Transport Oriented Development (TOD) 20-22 Atchison Street, St Leonards

State Significant Development Assessment Report (SSD-87486461)

Figure 5 | Building separation to the neighbouring property at 6-16 Atchison Street (Source: EIS)

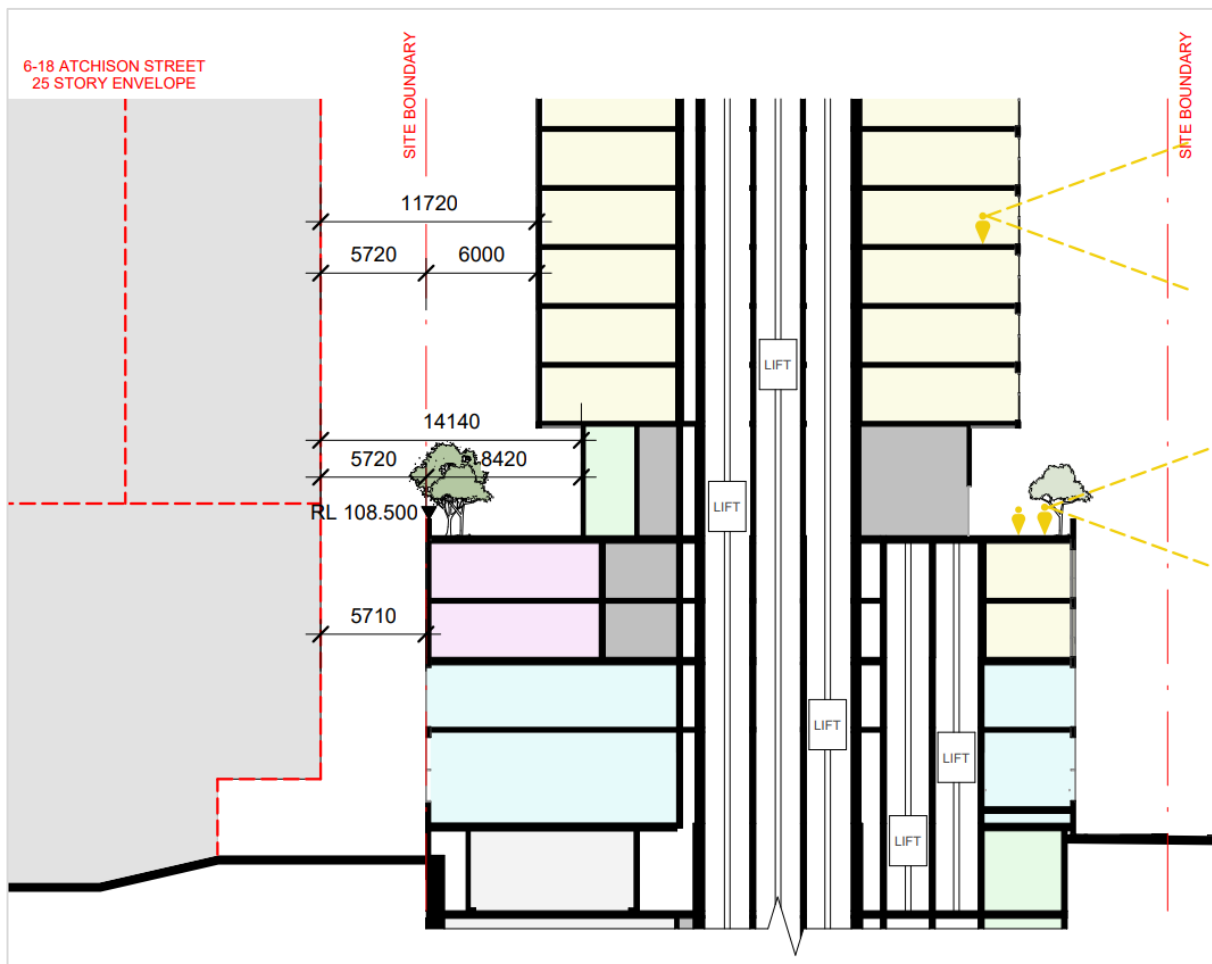
The proposed building separation to the adjoining property to the west at 6-16 Atchison Street does not meet the recommended ADG design criteria, providing a 0 m setback at the residential podium levels (Levels 2 and 3) and a 6 m tower setback. The proposed separation distance to the neighbouring building is shown in **Figure 5** below.

Council raised concerns that the non-compliant setbacks would result in an overbearing building with intrusive bulk and scale. The building separation distance and perceived bulk and scale of the proposal was also raised as a concern in the public submissions.

The Department has carefully considered the setback and building separation to the western boundary, as well as the Applicant's response and considers the proposal to be acceptable as:

- there are no windows on the western facade of the building, therefore preventing any direct lines of sight or overlooking opportunities and maintaining visual privacy of the neighbouring property which currently incorporates privacy screening on its eastern elevation

- the tower setback of 6 m is slightly greater than the 5.7m tower setback at 6-16 Atchison Street, responding to the existing built form of the neighbouring development and character of the surrounding area

Overall, the Department is satisfied that the proposal aligns with the building separation and visual privacy objectives outlined in the ADG and would provide an acceptable level of visual privacy for future residents on the site and the neighbouring building to the east.
